GJS Plot F, Manchester

Non-material Amendment | 25.09.2024

Z1-SHP-A180-RP-XX-NMA02 | P05

Updated proposal - Z1-SHP-G100-PL-B2-B5D801 - P02

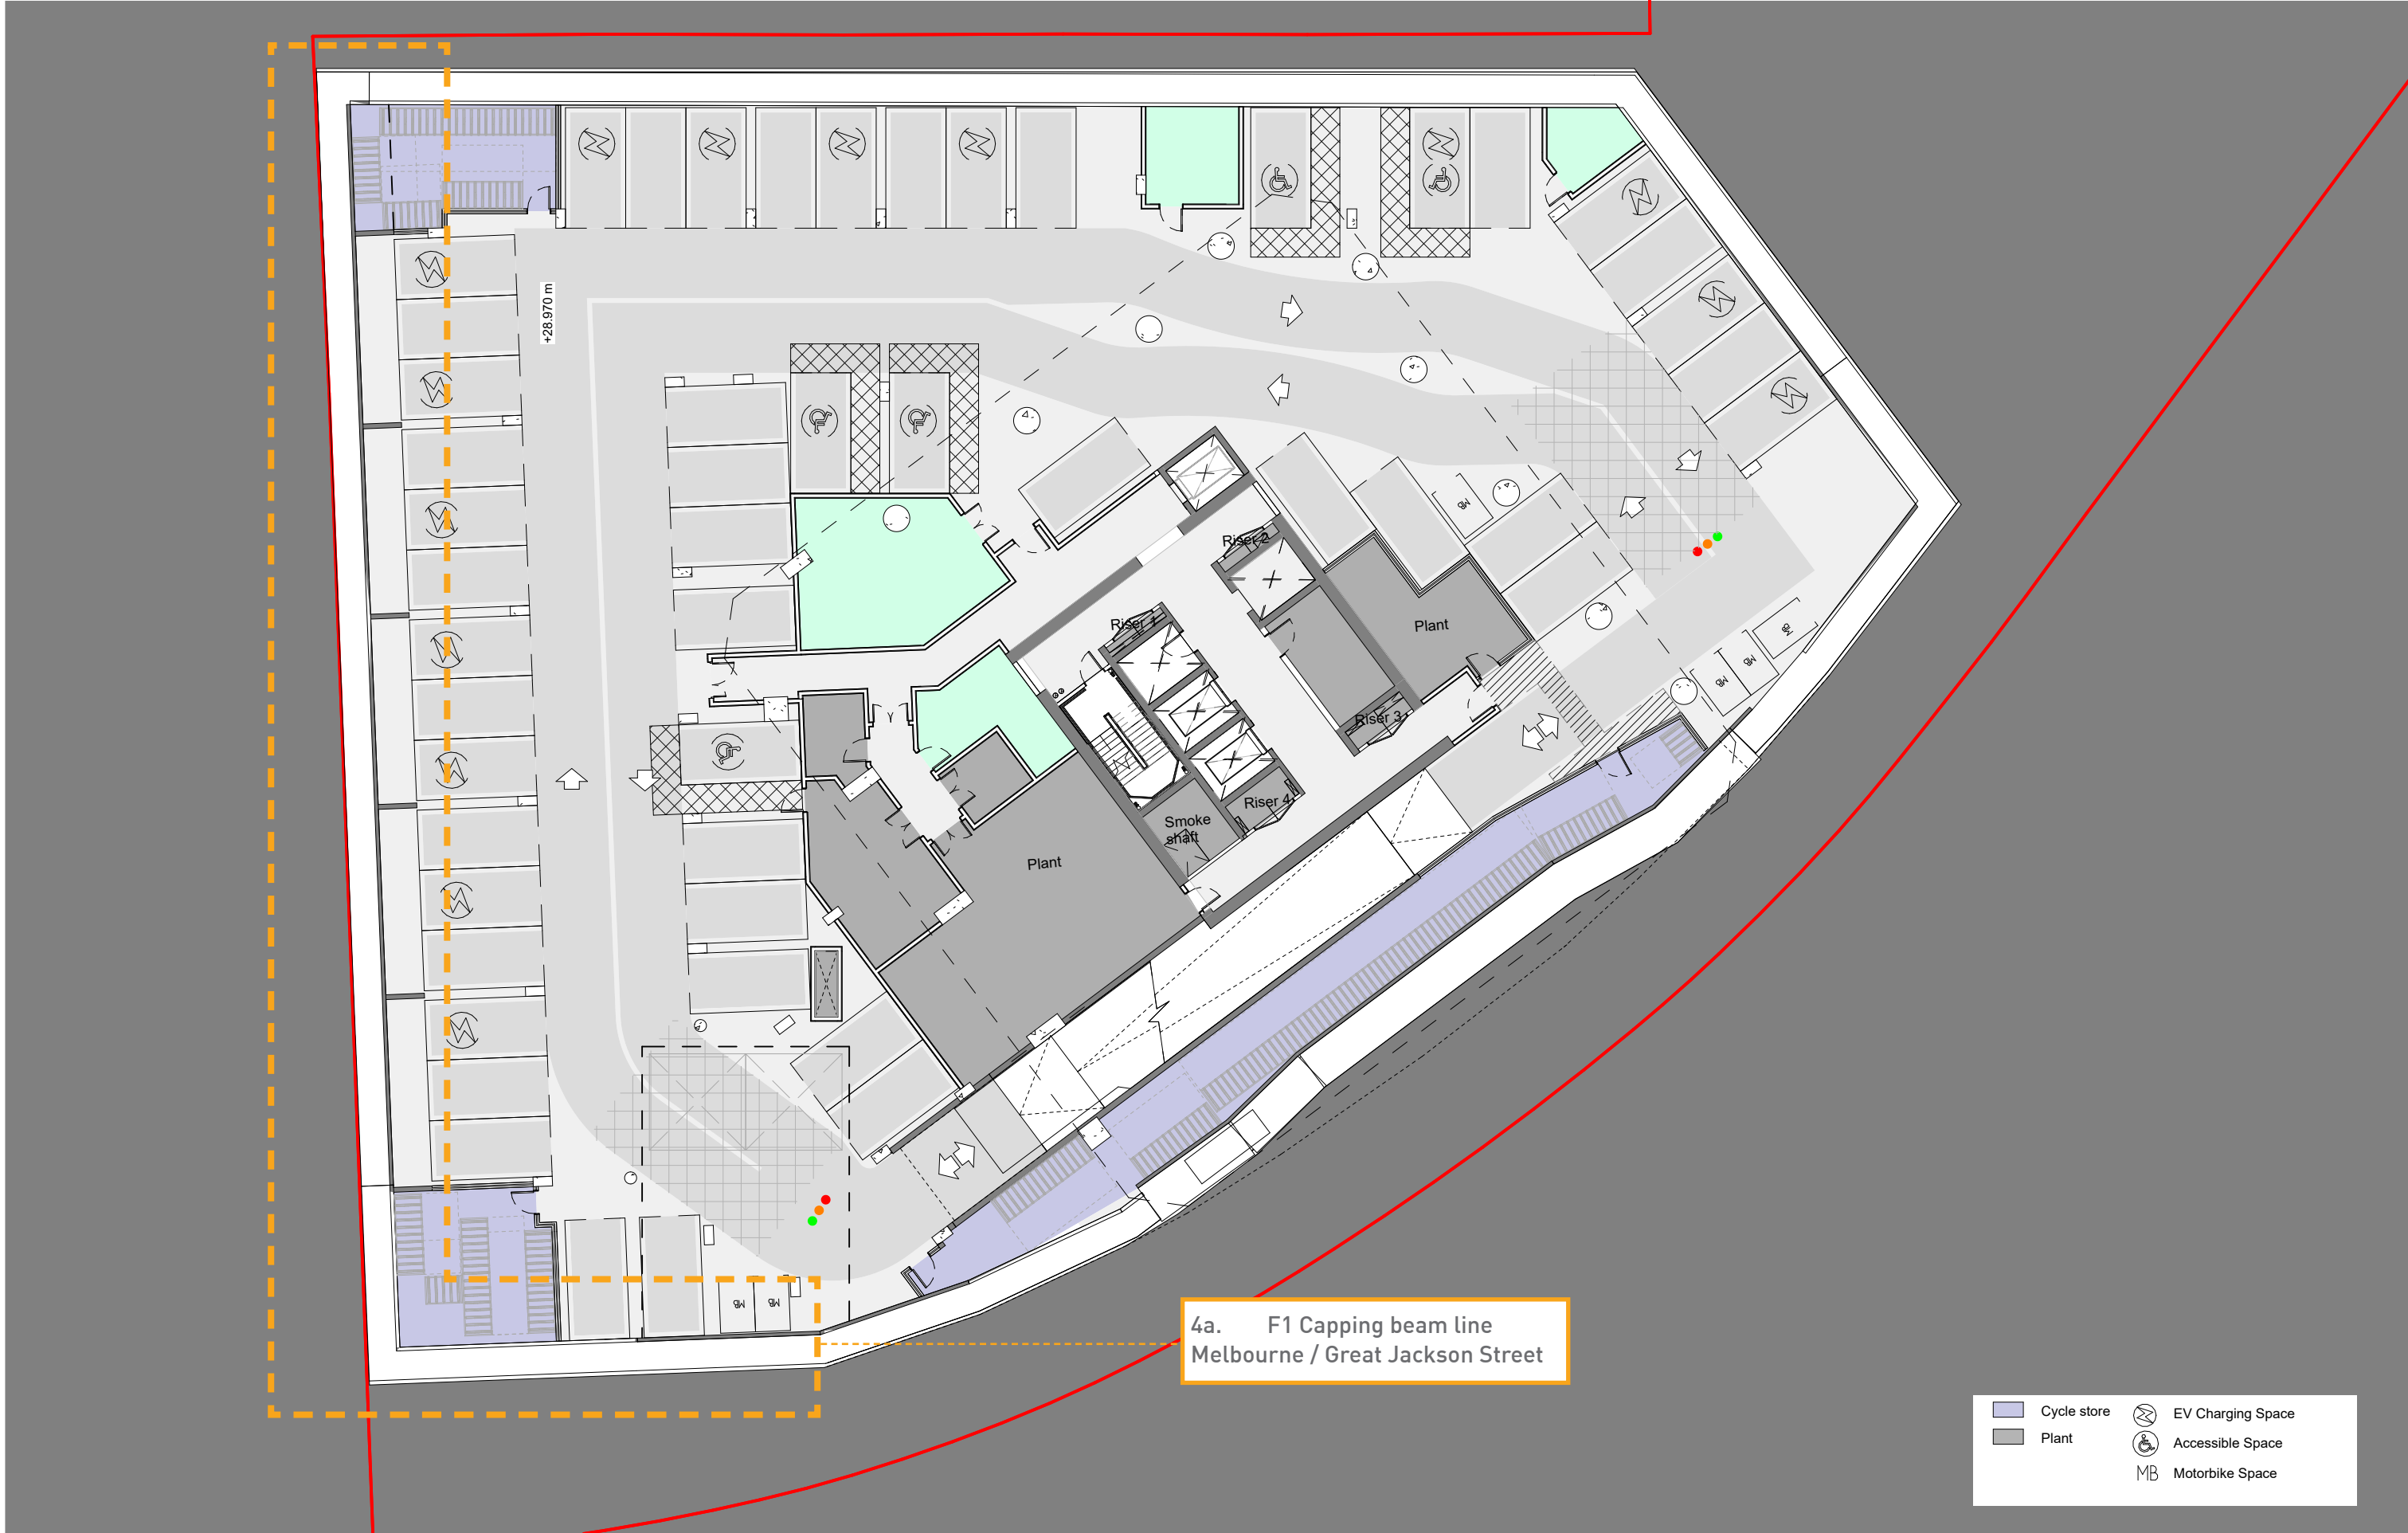
1.	Tower F1 - Removal of visible capping beam along Great Jackson Street At planning stage it was deemed neccessary to keep the capping beam (top of the basement piled wall) above ground level, due to the proximity of the F1 capping beam to the pavement. Through further structural design and refinement of temporary works, the design team have been able to lower the entirety of this structure so that it is not visible from street level, with the following benefits: <ul style="list-style-type: none">- Feature columns are able to run full height - are not interrupted by the capping beam structure.- The public realm between the development and the pavement is more successful allowing for a more natural pedestrian circulation around the building without this imposition.	4.	F1 Basement updates a. F1 Capping beam line Melbourne / Great Jackson Street The alignment of the capping beam for the F1 basement running down Melbourne Street has also been amended to tie in with the Crown Street Phase 3 application. The revised arrangement reflects the applicant’s updated land ownership and allows for construction efficiencies within the back to back basement design. Quantum of car parking, EVC and accessible provision remains as per consented.
